MIL-C-9897B
AMENDMENT 1
17 June 1976

**CRATES, SLOTTED ANGLE, STEEL OR ALUMINUM, FOR LIGHTWEIGHT AIRFRAME
COMPONENTS AND BULKY ITEM (FOR MAXIMUM LOADS OF 3000 POUNDS)**

This amendment forms a part of Military Specification MIL-C-9897B, dated 23 July 1974, and is approved for use by all Departments and Agencies of the Department of Defense.

FIGURE 17

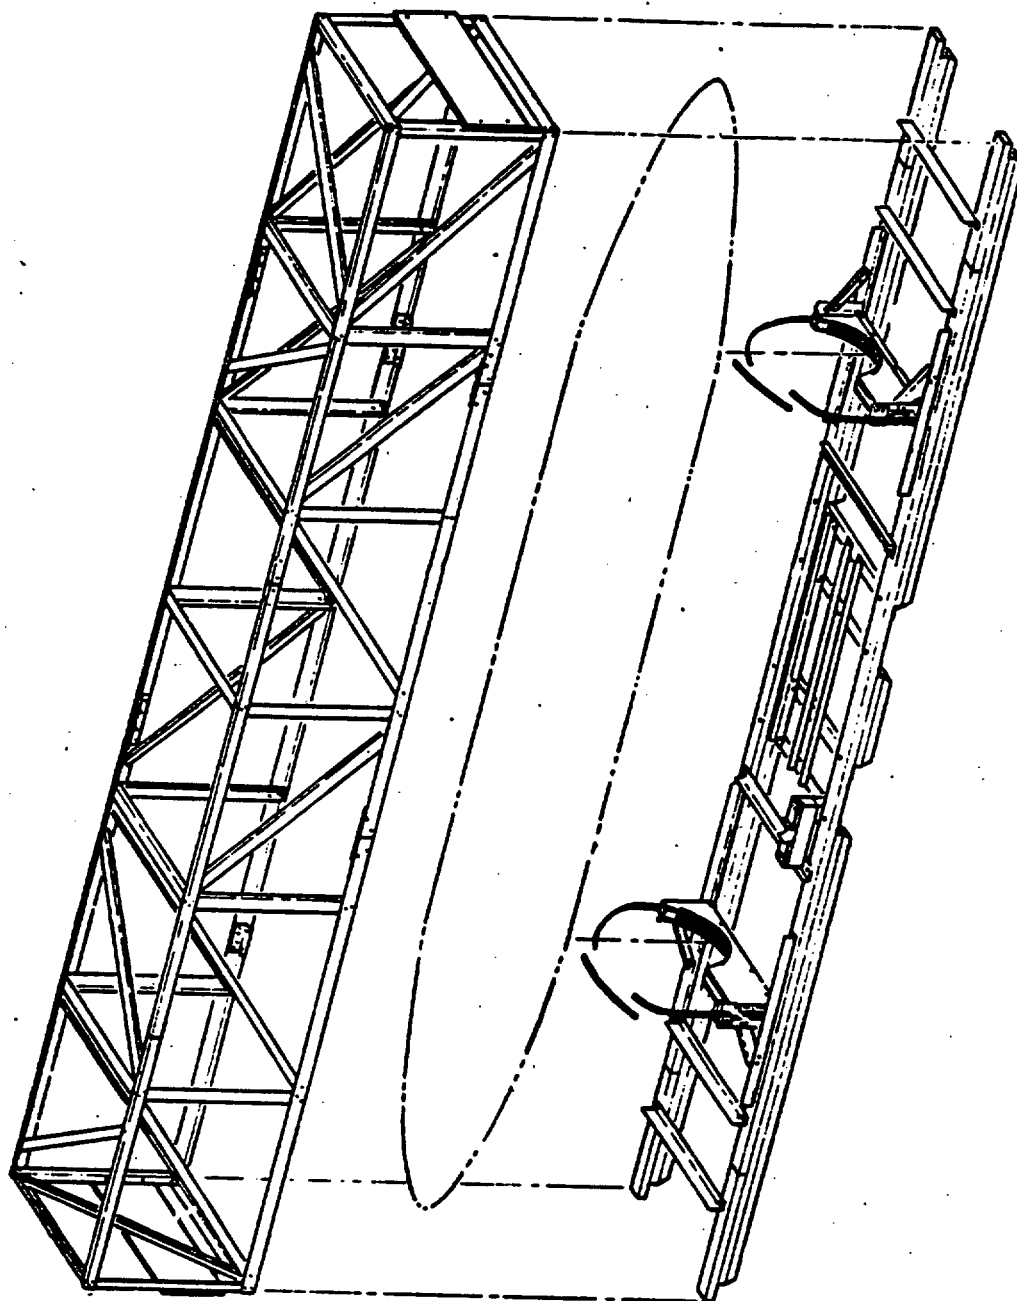
3.3.3: Delete fourth sentence and substitute, "Flooring shall be cut to fit in place and should be bolted to the lower side rails of the crate, except when crates are constructed in accordance with Figure 17."

3.8, line 4: Change "shock and vibration isolation systems," to read "shock and vibration isolation systems, removable superstructures (see Fig. 17),".

Following page 38: Insert new page 39, Figure 17.
